Subject: Oroville Facilities Relicensing - Comment submittal

ALTERNATE ROUTES TO LAKE OROVILLE FROM HWY 70

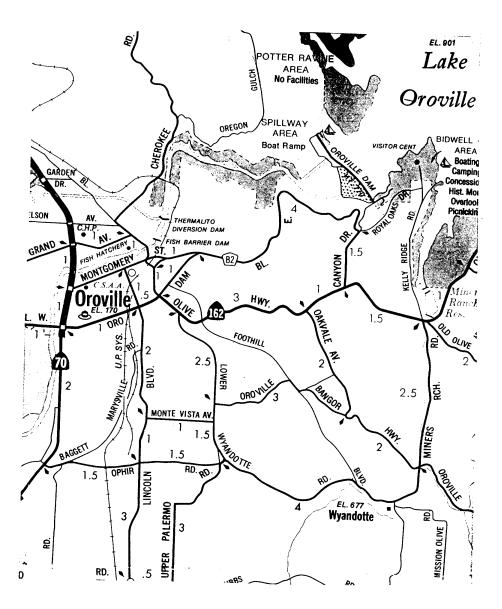
I enclose a map showing alternate routes to these locations which routes would help alleviate congestion on Hwy 162. Observe that:

- 1- Spillway visitors from the north could use Garden Drive, Nelson Ave. or Montgomery St. offramps to Oro Dam Blvd. along the river for direct access.
- 2- Spillway visitors from the south could use Hwy 162 Oro Dam Blvd. along the river.
- 3- All other above mentioned destinations could also be reached from the north via Hwy 162 alone.
- 4- The same destinations as in 3- above could be reached from the south via Ophir Rd., Wyandotte Rd. and Miner's Ranch Rd. to Hwy 162, thence to the various final locations.

I request that DWR study the aspect of access to the Project and coordinate with Caltrans and Butte County Public Works Departments to make best utilization of available routes for maximum reduction of impact on Hwy 162. At the vary least, the Relicensing effort should include thorough signing on all alternate routes and an organized effort to inform and encourage the visitiors with their options for access. G-09-02 G-09-03
